Access Compliance Report

Public Rights-of-Way

(Curb Ramps)

Intersection ID: 3219	Main Street: HAMPTON_PLACE_DR	Cross Street: SHADOW_PINE_DR	Location: NE
ADA ID: C10428899F90	Ramp Type: Perp	Initial Pass/Fail: Fail	Overall Compliance: No
Severity Score: 12.5			
Codes/Mitigation Info/Possible Solution		Field Measurements/Component Compliance

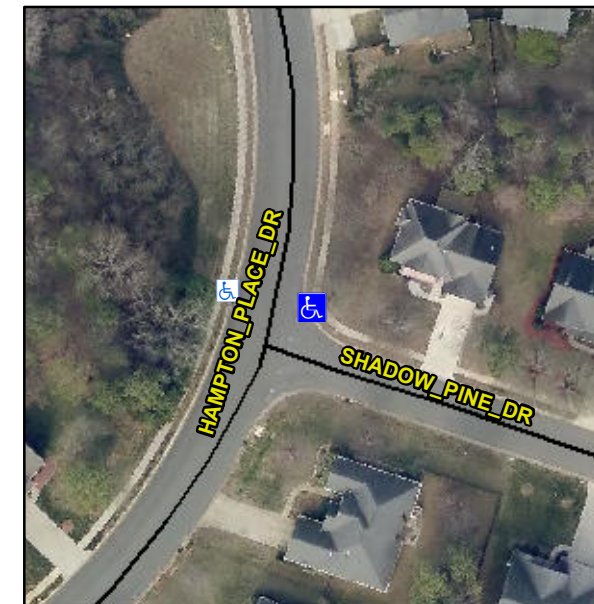
Not Found, R304.5.3

Compliance	Description	Data	Compliance	Description	Data
N/A	Ramp Length (in)	50.0	Yes	Ramp Slope (%)	6.2
Yes	Ramp Width (in)	59.0	No	Ramp XSlope (%)	5.7
N/A	Flare Type LT	N/A	N/A	Flare Type RT	N/A
N/A	Flare Slope LT (%)	N/A	N/A	Flare Slope RT (%)	N/A
N/A	Flare Traversable LT?	N/A	N/A	Flare Traversable RT?	N/A
N/A	Landing Length (in)	N/A	N/A	DWS Provided?	N/A
N/A	Landing Width (in)	N/A	N/A	DWS Contrast?	N/A
N/A	Landing Slope (%)	N/A	N/A	DWS Length (in)	N/A
N/A	Landing X Slope (%)	N/A	N/A	DWS Full Width?	N/A
N/A	Landing Curb? (Y/N)	N/A	N/A	DWS Offset (in)	N/A
N/A	Shared Landing?	N/A			
N/A	Gutter Ponding?	N/A	N/A	Gutter Slope (%)	N/A
N/A	Gutter Lip Ht (in)	N/A	N/A	Gutter X Slope (%)	N/A
N/A	Painted X Walk1?	No	N/A	Painted X Walk2?	N/A
	X Walk 1 Direction	To W		X Walk 2 Direction	N/A
N/A	X Walk 1 Width (in)	N/A	N/A	X Walk 2 Width (in)	N/A
	X Walk 1 Slope (%)	0.6		X Walk 2 Slope (%)	N/A
	X Walk 1 X Slope (%)	8.2		X Walk 2 X Slope (%)	N/A

Remove & Replace Entire Ramp.
